# Wimblehurst Road Residents Association

## **Ref: Outline Planning Application DC/25/0629, Former Novartis Site, Parsonage Road, Horsham RH12 5AA Amended Proposals**

### **Stance of response for Amended Plans for Outline Planning Application DC/25/0629: Object**

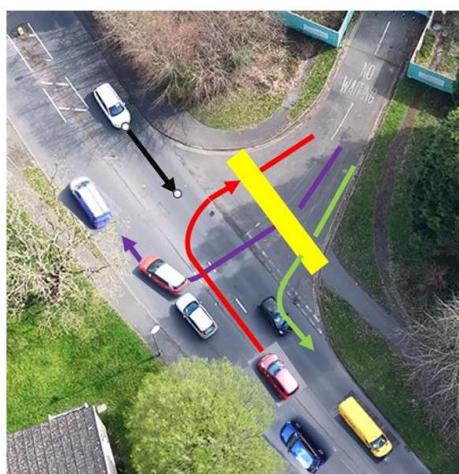
A photomontage created from drone photographs commissioned by WRRA gives an indication of the complex paths of traffic at the Wimblehurst Road exit. The yellow path is the pedestrian route.

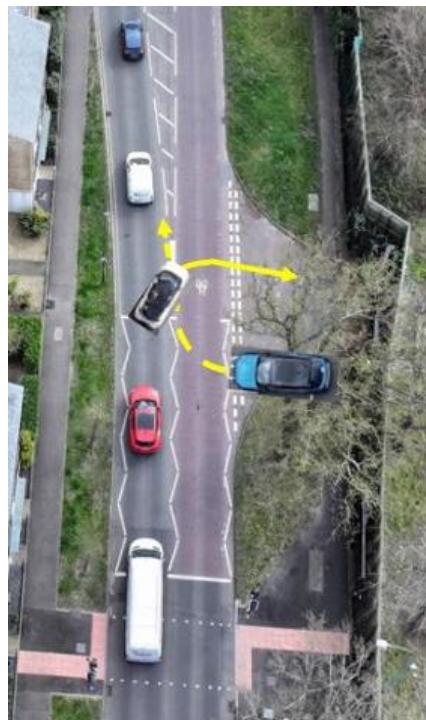
In the case of the Parsonage Road entrance the paths are shown in the photomontage below.

In the process of demolition 25 tonne tipper lorries will approach the site from the level crossing at the top of the photograph. As they approach the junction they will need to slow down and take a fairly wide placement on the traffic lane to cope with the acute left turn, given the turning radius of these lorries.

The exit will be more challenging. The fully-laden lorry will need to have a good period of time to cross the first lane of traffic and turn into the east-bound lane.
